RENESAS TECHNICAL UPDATE

| Product Category | MPU & MCU | Document No. | TN-16C-A238A/E | Rev. | 1.00 |
| Title | Deletion of Specifications and Errata for R32C/116A Group User's Manual: Hardware | | Information Category | Technical Notification | |
| Applicable Product | R32C/116A Group | Lot No. | Reference Document | R32C/116A Group User's Manual: Hardware Rev. 1.10 (R01UH0213EJ0110) | |

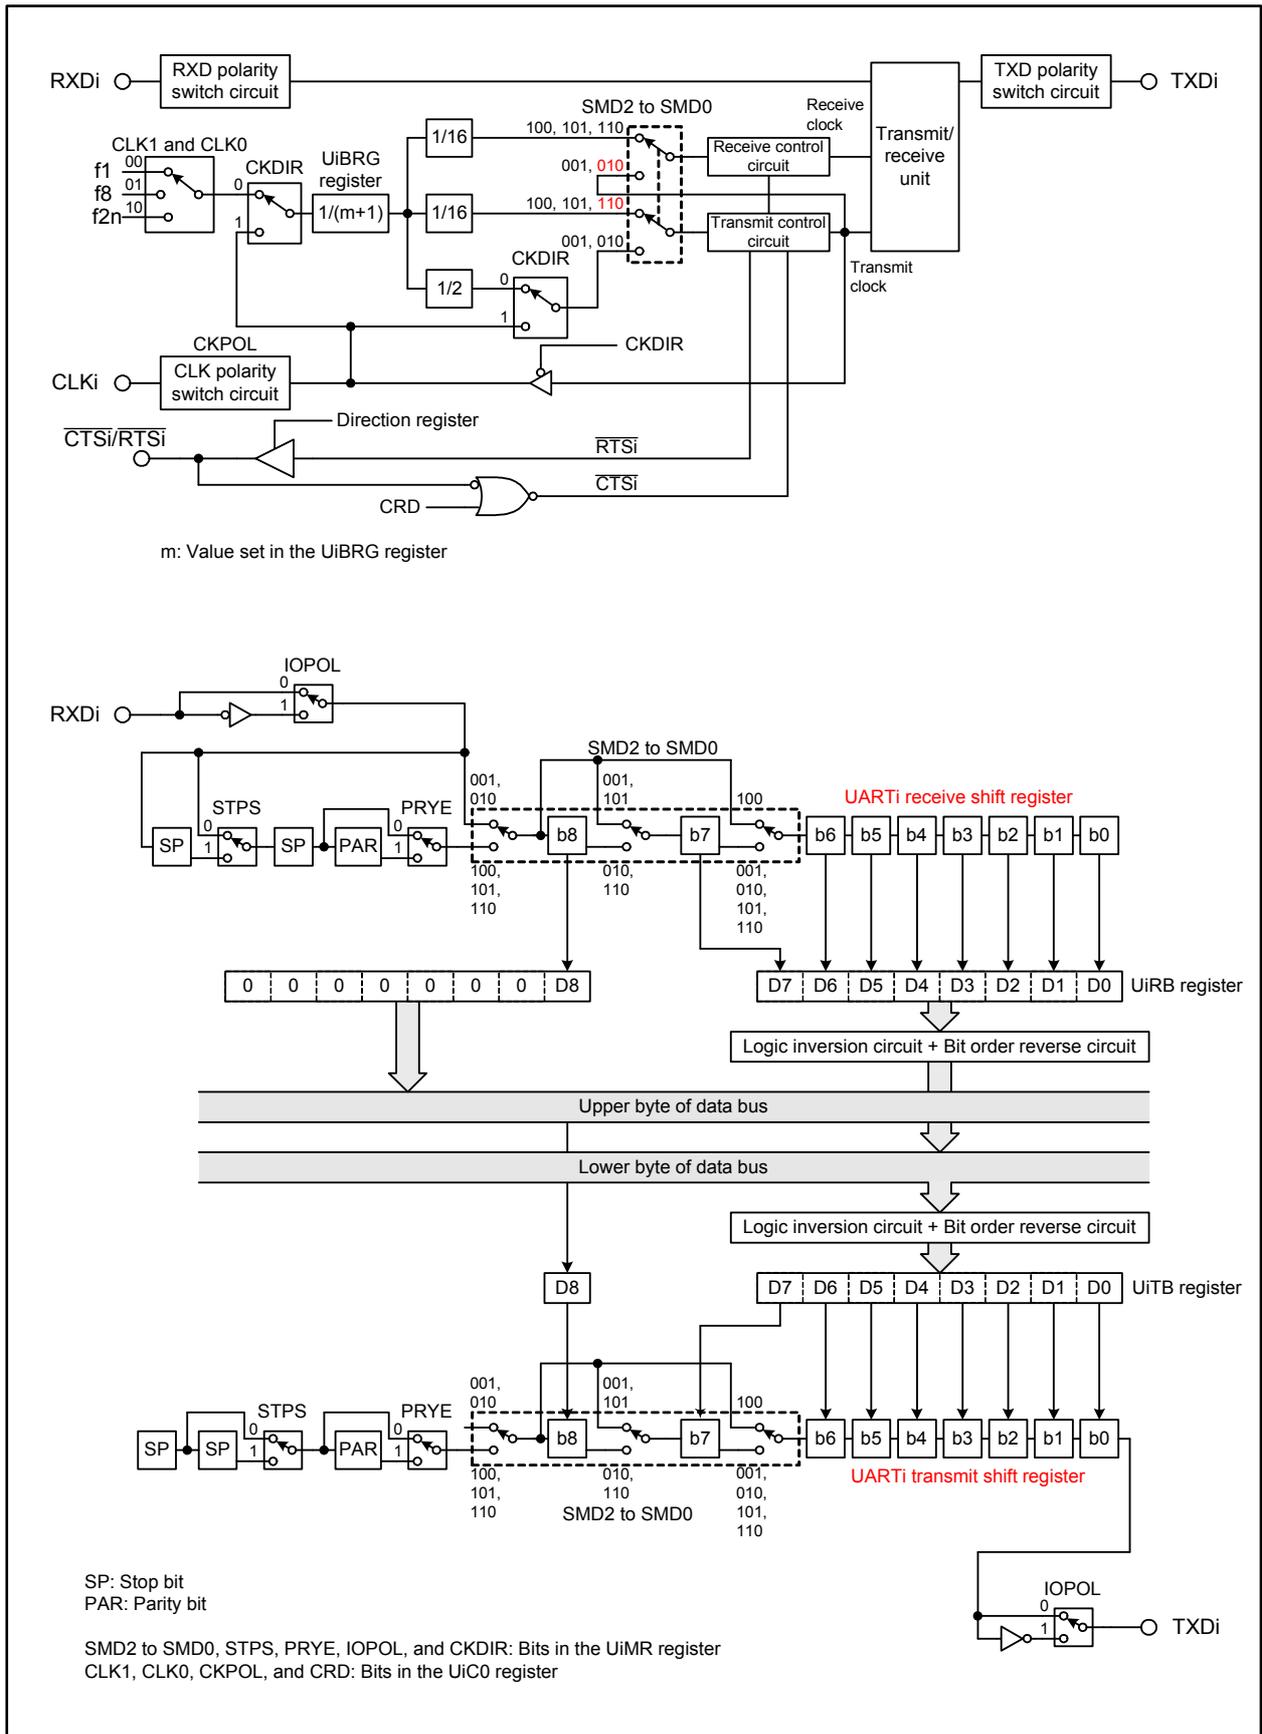
•Page 241 of 541, positions of “010” for bits SMD2 to SMD0 in Figure 18.1 are corrected as follows:

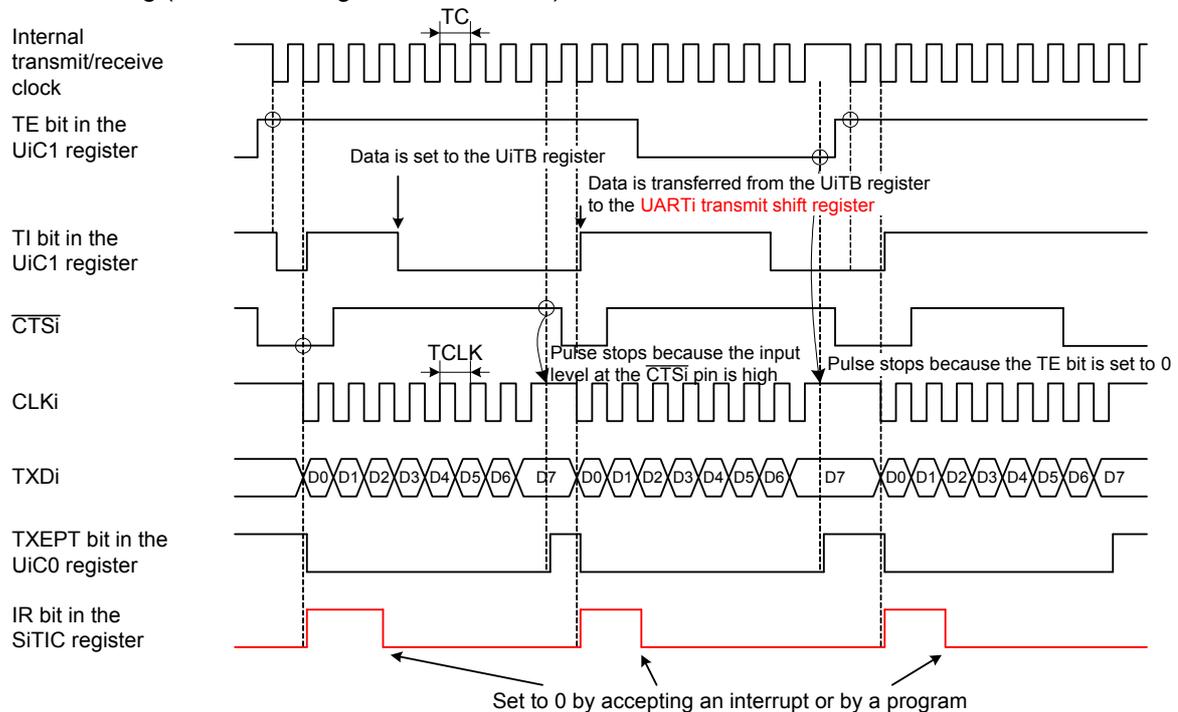
- Page 251 of 541, expression “baud rate generator count source” in the function of bits DL0 to DL2 in Figure 18.13 is corrected as follows:
 “count source for the UiBRG register”
- Pages 258, 259, 266, 267, 276, 286 of 541, descriptions in Function of the UiBRG register in Tables 18.3, 18.4, 18.6, 18.7, 18.10, and 18.15 are modified as follows:
 “Set the divide ratio according to the bit rate”
- Pages 259, 267 of 541, description for (b7 to b4) to registers UiC1 and U78CON in Tables 18.4 and 18.7 is added as follows:
 “(b7 to b4) Set the bits to 0000b”
- Page 260 of 541, waveform of the IR bit in Figure 18.21 is corrected as follows:

Transmit timing (when selecting an internal clock)

This figure applies under the following conditions:

- The CKDIR bit in the UiMR register is 0 (internal clock).
- The CRD bit in the UiC0 register is 0 (CTS function enabled).
- The CKPOL bit in the UiC0 register is 0 (output transmit data on the falling edge of the transmit/receive clock).
- The UiIRS bit in registers UiC1, U78CON, and U910CON is 0 (an interrupt request is generated when the transmit buffer is empty).

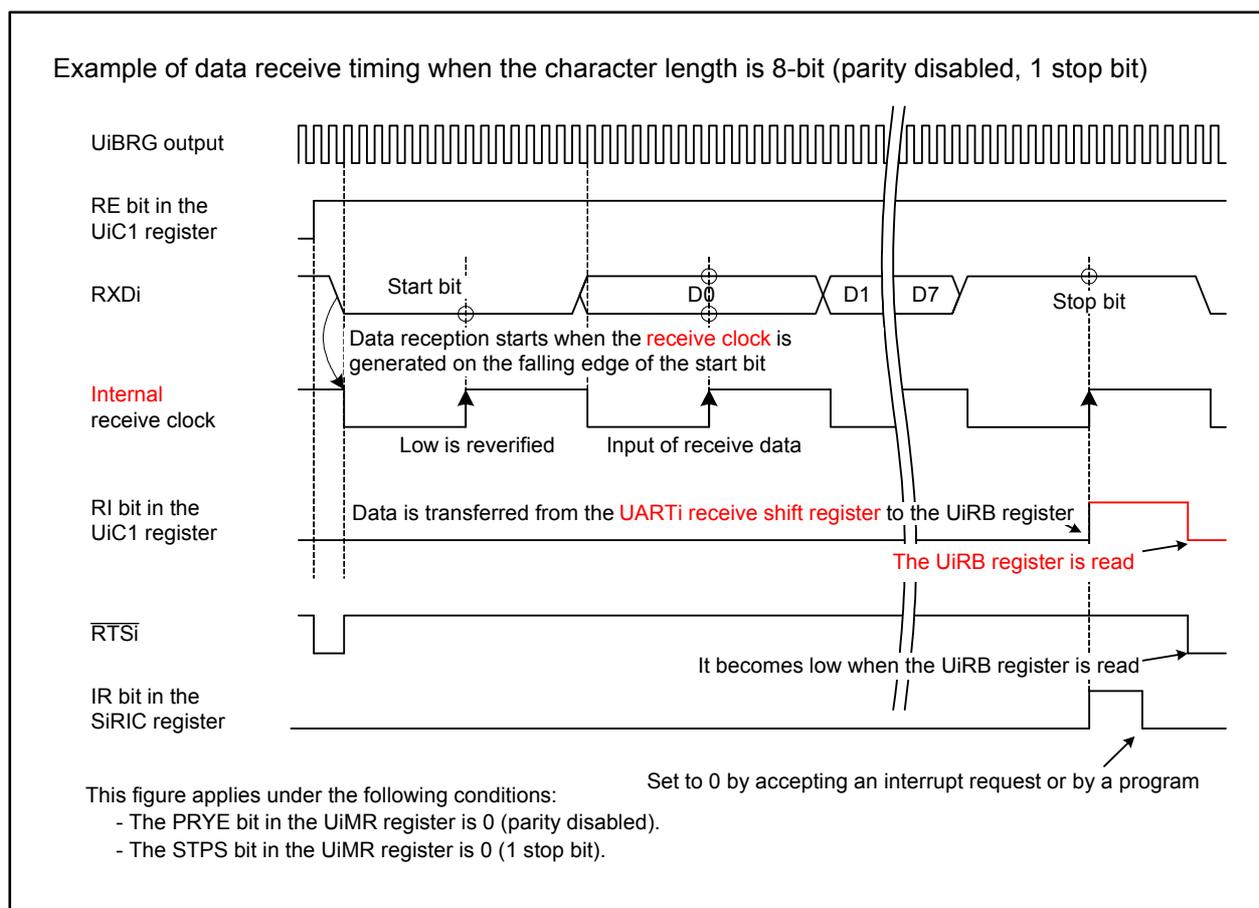
•Page 270 of 541, Figure 18.28 is corrected as follows:
